UNITED STATES
NUCLEAR REGULATORY COMMISSION
WASHINGTON, D. C. 20555
November 6, 1978

SURRY POWER STATION, UNIT NO. 1

Amendment No. 44
License No. DPR-32

SAFETY EVALUATION BY THE OFFICE OF NUCLEAR REACTOR REGULATION

**VIRGINIA ELECTRIC AND POWER COMPANY
SURRY POWER STATION
ORGANIZATION CHART**

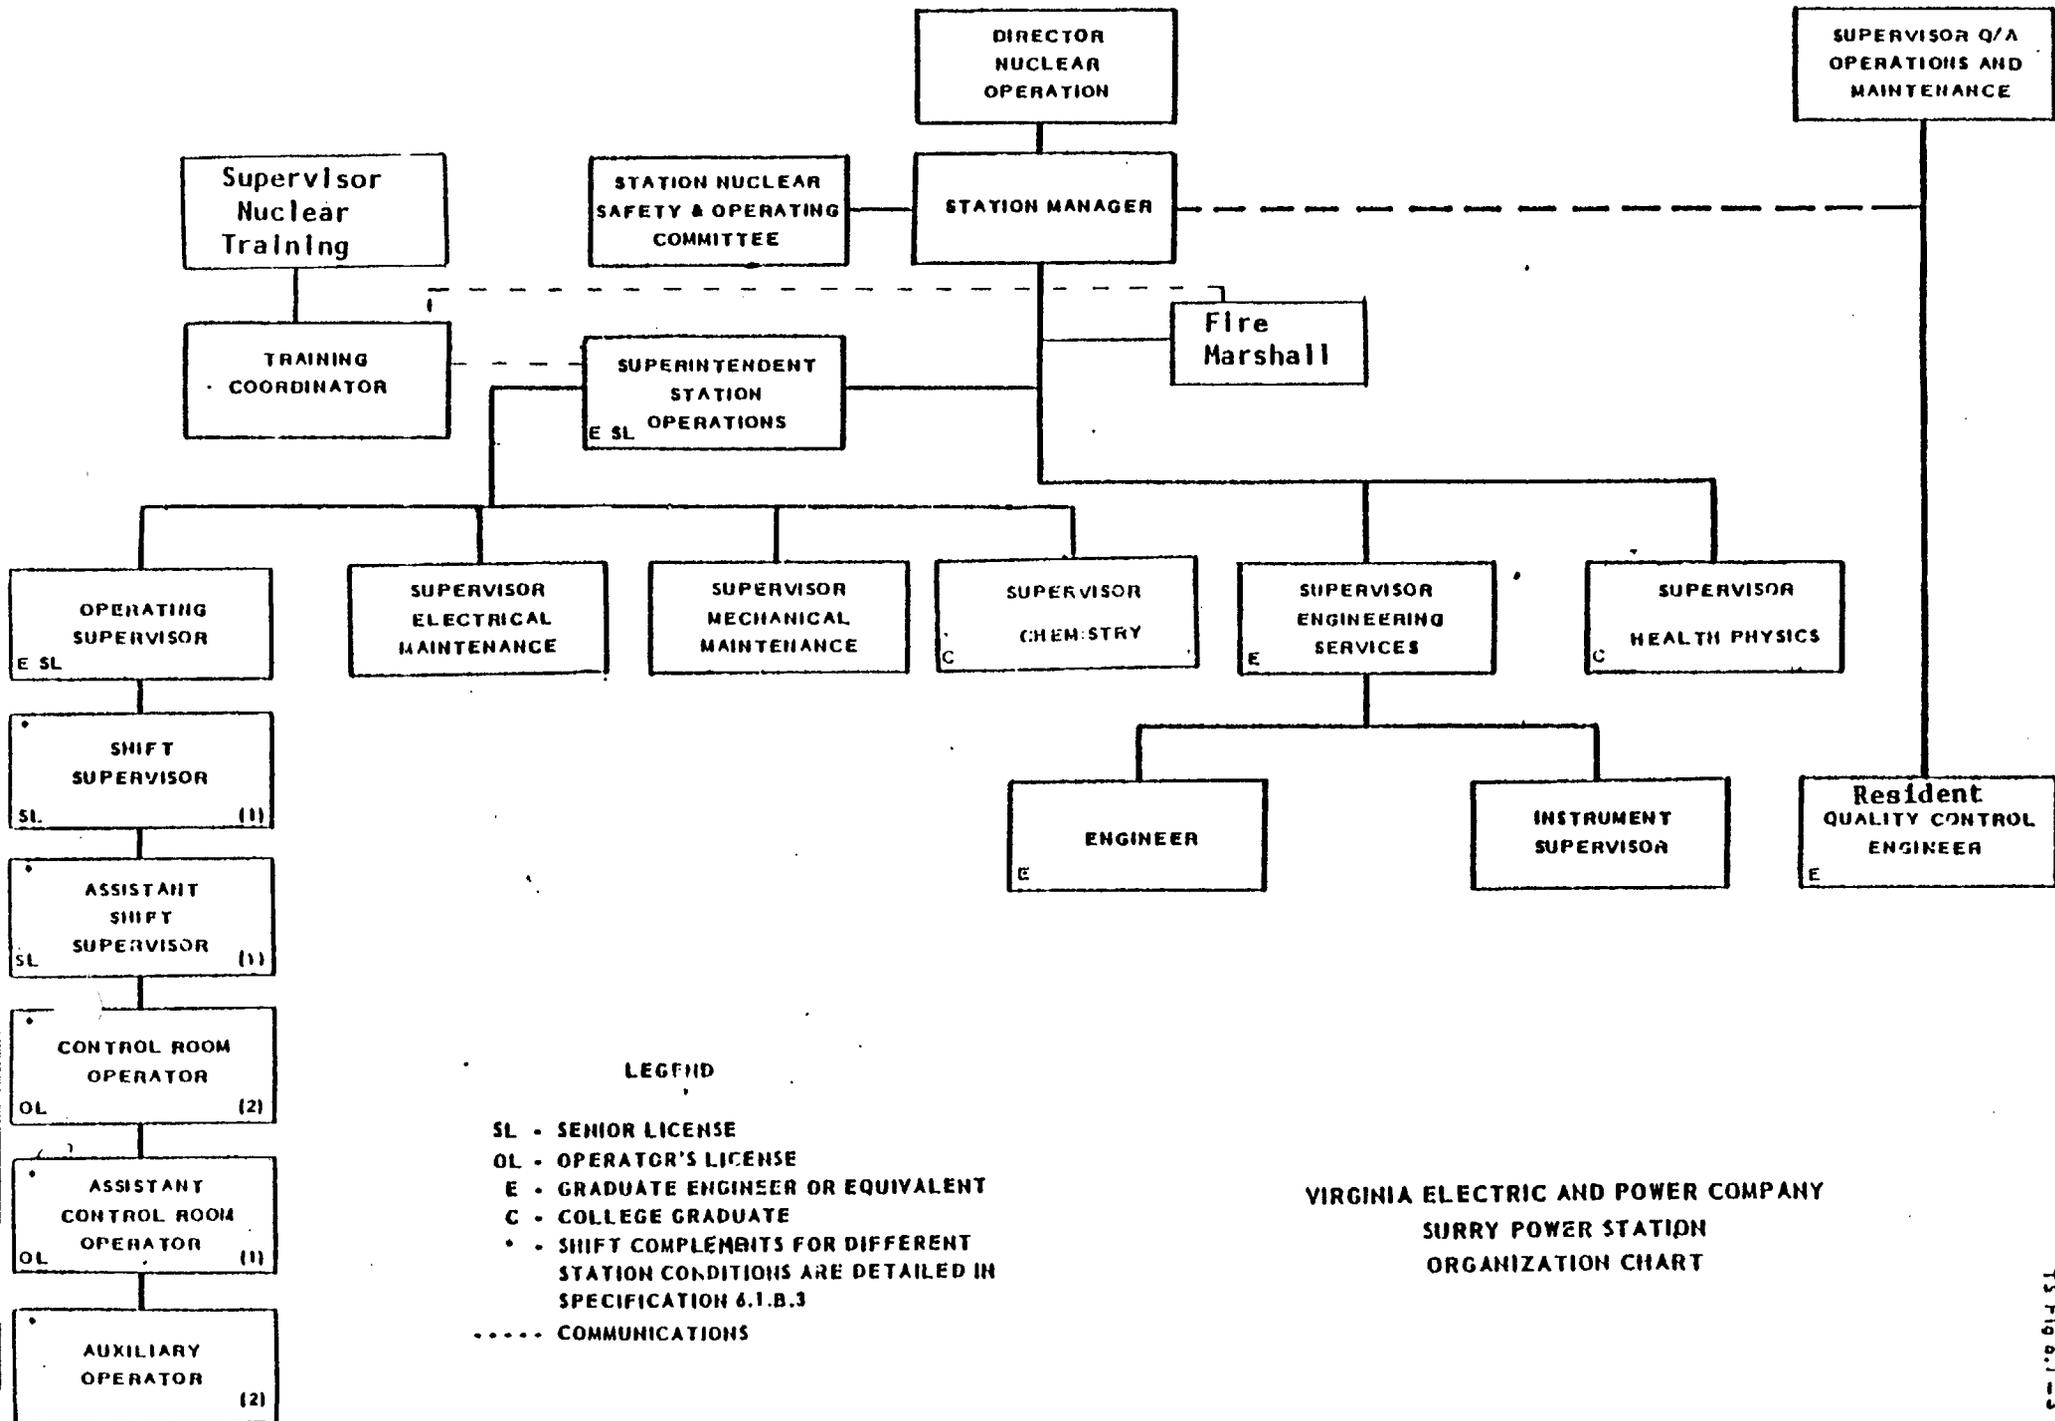
These changes to the Technical Specifications, (1) reduce the allowable pressurizer heatup rate from 200°F/hr to 100°F/hr, (2) reflect a new title of "Resident Quality Control Engineer" to replace "Quality Control Engineer," and (3) correct a typographical error on page TS 3.16-2 which was issued on May 10, 1978.

These changes to the Technical Specifications, (1) reduce the allowable pressurizer heatup rate from 200°F/hr to 100°F/hr, (2) reflect a new title of "Resident Quality Control Engineer" to replace "Quality Control Engineer," and (3) correct a typographical error on page TS 3.16-2 which was issued on May 10, 1978.

| 12. Quality Assurance | Resident Quality Control Engineer |
